TITLE: SPECIAL PERMIT NO. 16018 -
(Residential healthcare facility - 7601 Pine Lake Road).

PROJECT #: Special Permit No. 16018 - Pemberly Place

PROPOSAL: A request per Section 27.63.530 for a Residential Health Care Facility

EX 1

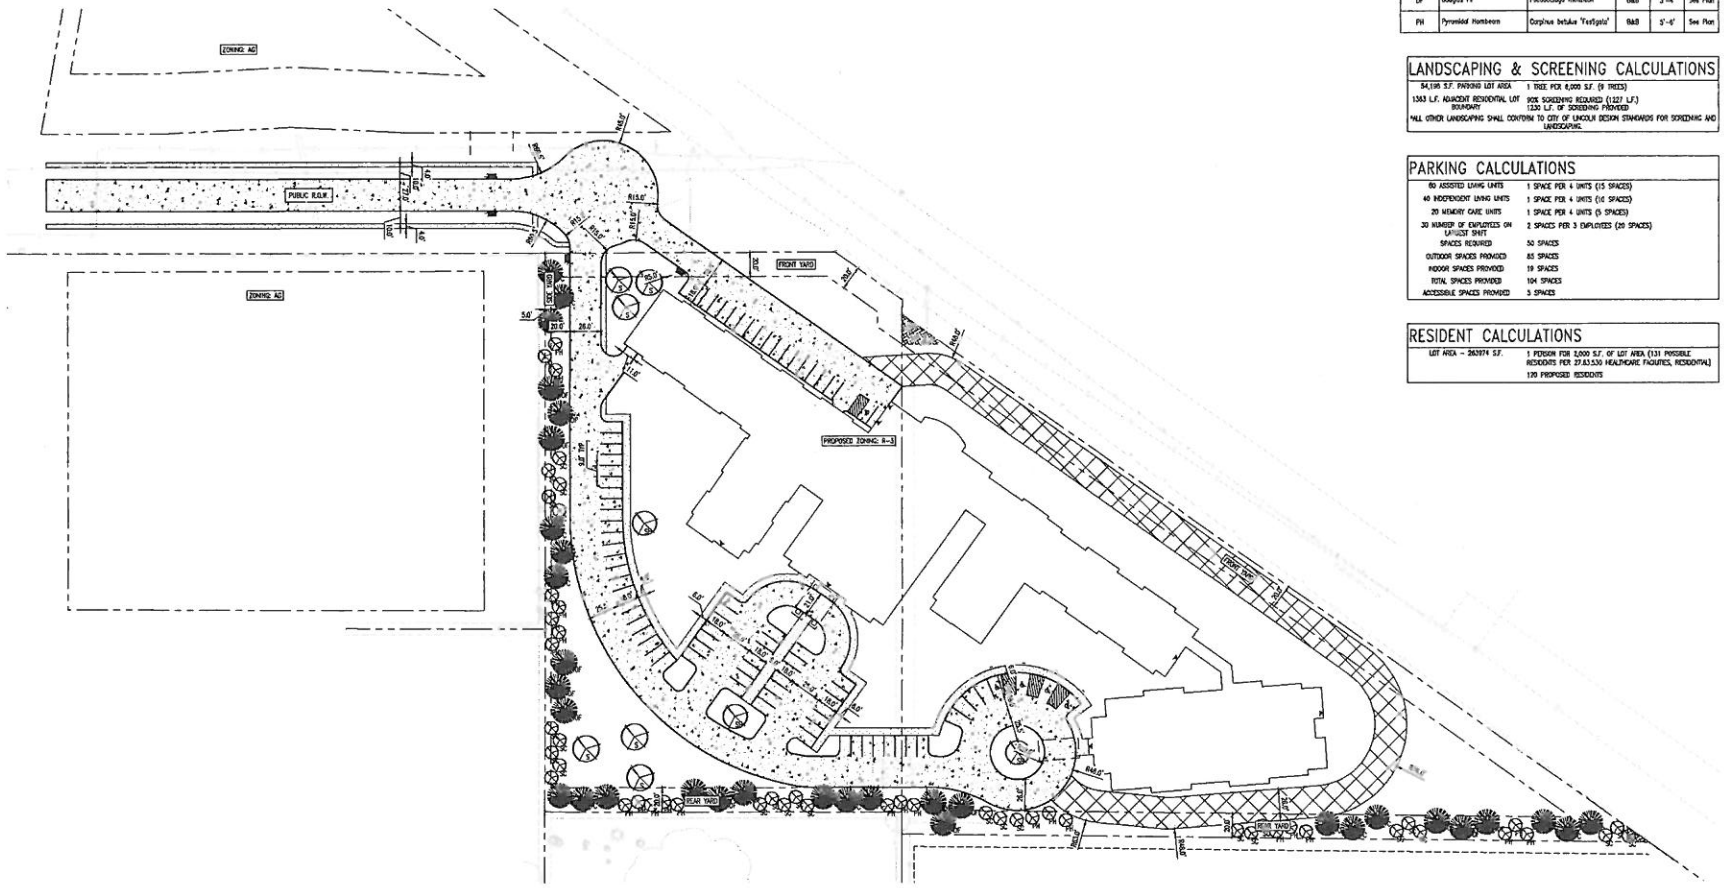
The site plan shows there to be 120 residents, and 20 employees on the largest shift requiring 50 parking spaces. There are 104 spaces provided on site, with 85 spaces located outside, and 19 spaces provided in an indoor parking garage.

5. A consistent screen surrounding the facility is necessary, and should be located in adequate open space. The rear setback in the R-3 zoning district is 20', and is provided in most areas along the west and south lot lines abutting residential uses. However, there are areas where either the parking lot or grass-pave emergency access drive encroach into this yard. The site plan needs to accommodate this required yard, and show it as open space where the screening can be located. This provides the type of separation and screening needed to mitigate locating a facility of this scale next to single-family dwellings.

1.2 Show the parking areas and grass-pave driveway located outside the 20' setback along the west and south property lines.

1.1 Delete the landscaping shown, and revise the landscape schedule to note that "Landscaping and screening to provided per Chapter 3.50, Sections 7.1 and 7.3."

C1-02

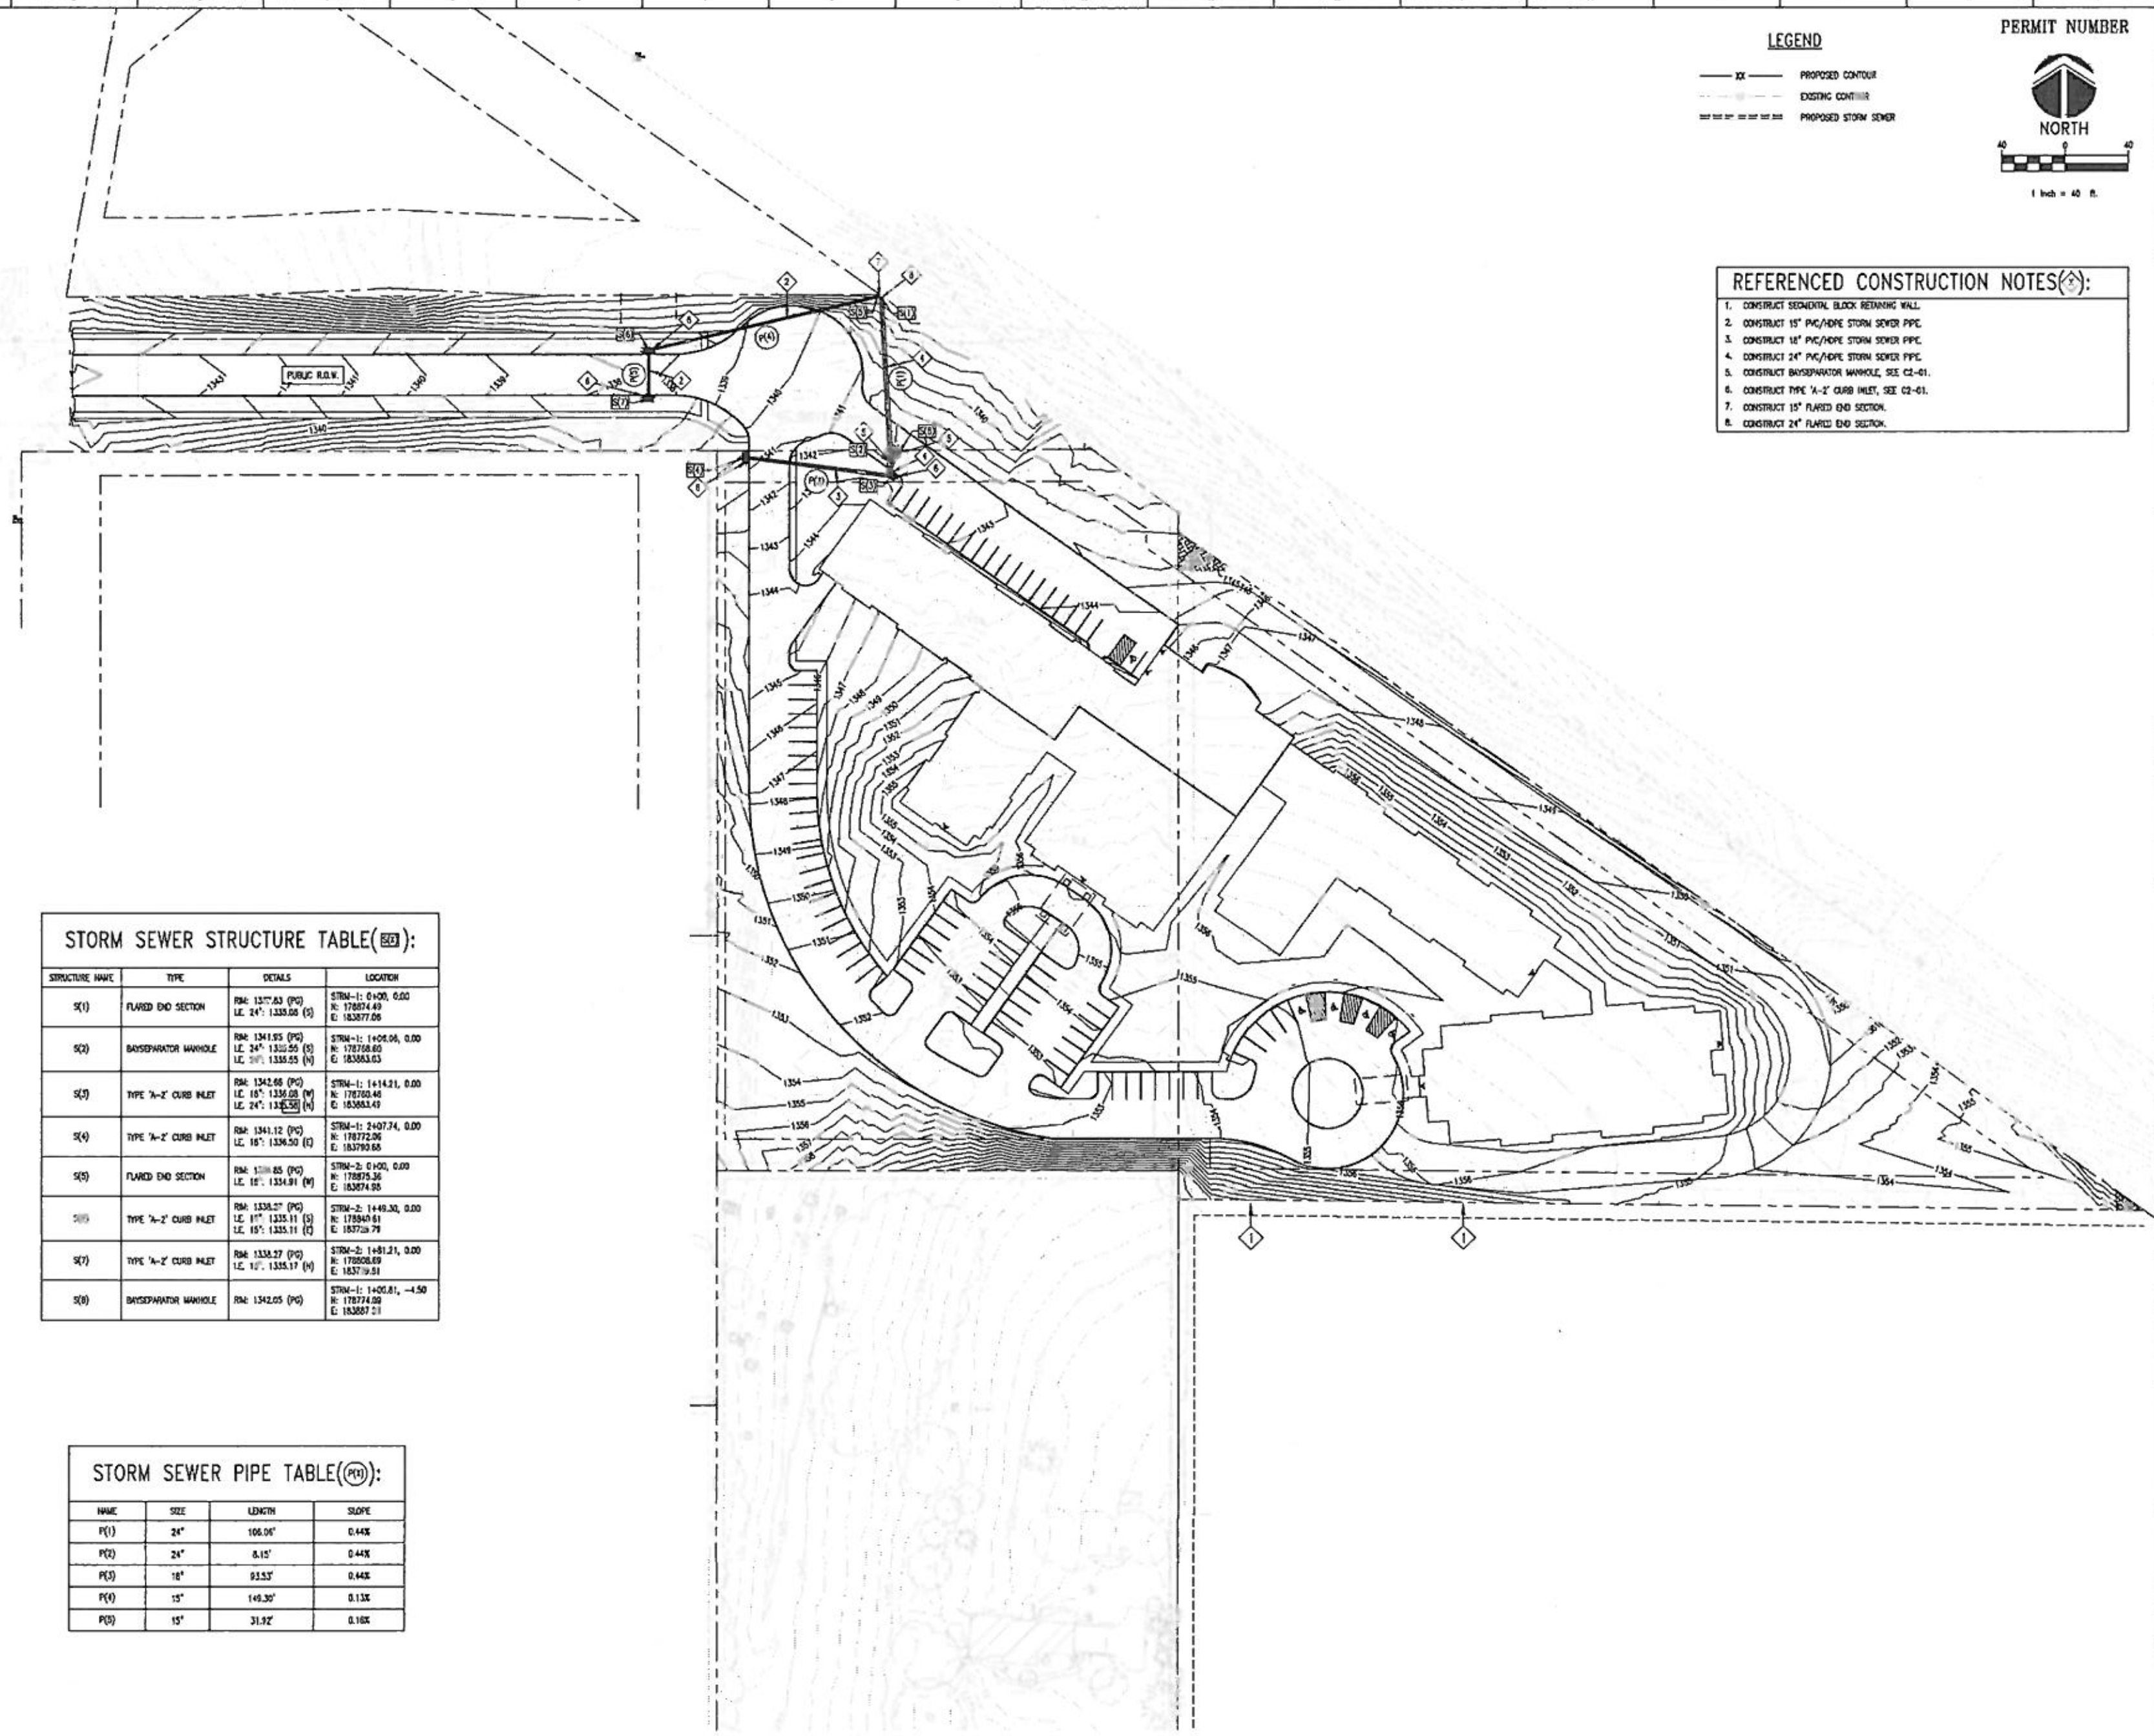
6. Storm water detention assumes the use of Highway 2 and an oversized detention facility further west along Highway 2. Public Works and Utilities had indicated this solution may be acceptable, but the applicant must apply for a waiver to the water quality design standards to develop the site as shown without on-site detention. The waiver can be approved administratively by Public Works and Utilities staff, but will need to be approved prior to building permits.

Watershed Management				development. Need to meet stormwater detention requirements. Need to get NDOR approval to discharge increased runoff to their property.

2.2 Approval by Public Works and Utilities of a waiver to the storm water detention regulations.

A2-02

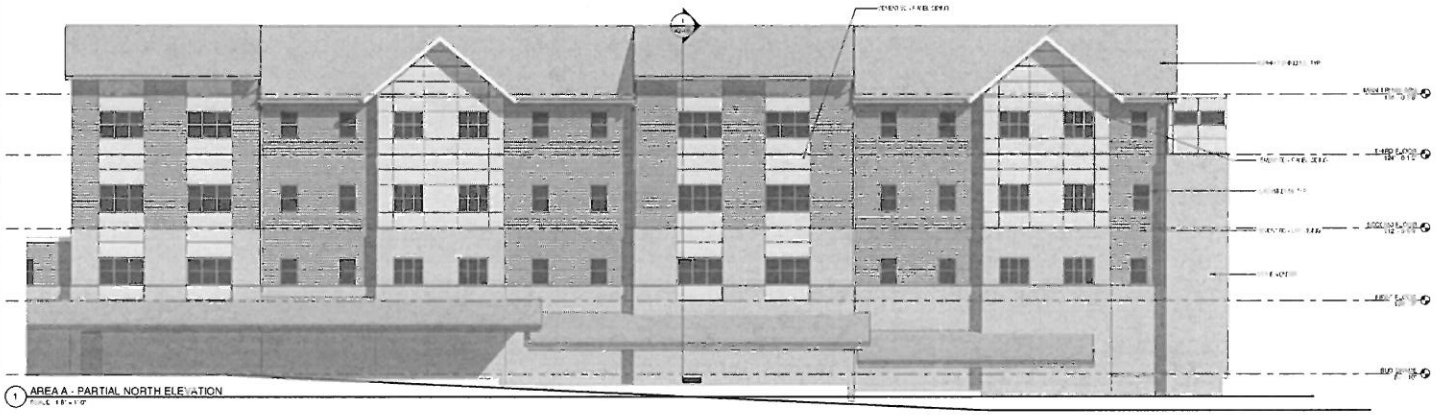
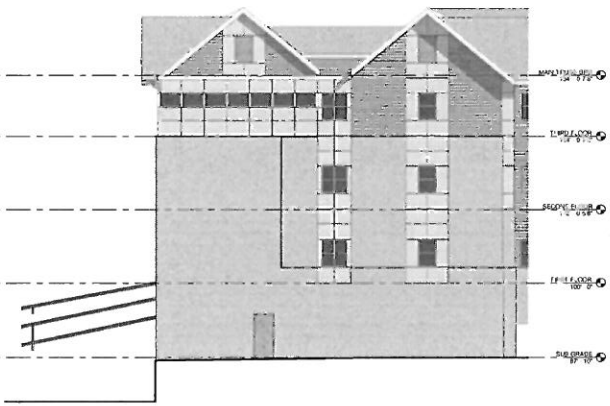
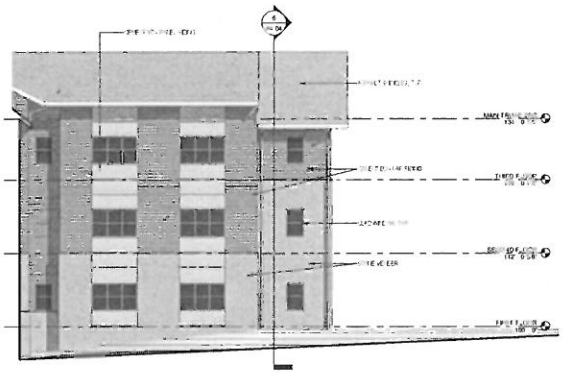
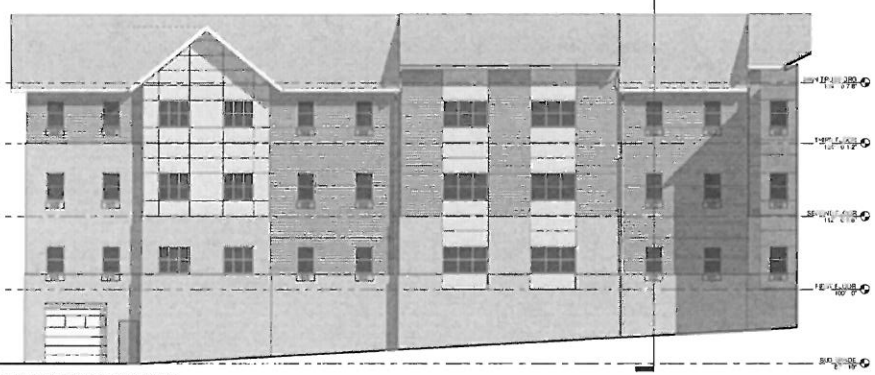
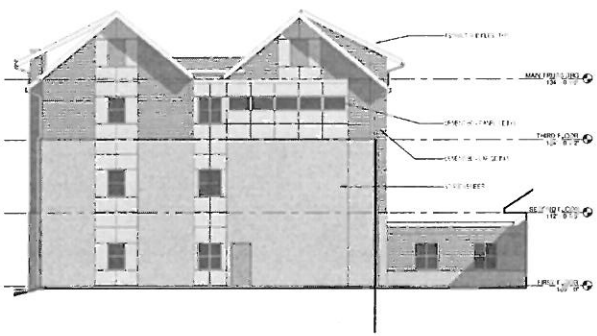
A three-story facility is proposed, with an adjustment to the maximum height limit of the R-3 zoning district from 35' to 44' has been requested. This is not an unusual request for modern buildings with higher ceilings and hipped roofs. It is common enough of a request for apartments that when they are a part of a community unit plan, the buildings can go to 45' in height provided they are setback from adjacent lot lines an equivalent distance.

This proposed development is surrounded by three-acre acreage lots developed with single-family dwellings. The large lots provide significant separation between uses. In this case, the nearest adjacent dwelling is over 300' away. The required landscaping will help mitigate the increased height (see the attached elevations provided by the applicant).

Per Section 27.63.580 this approval permits a residential health care facility for up to 120 residents with an adjustment to exceed the maximum height from 35' to 44'.
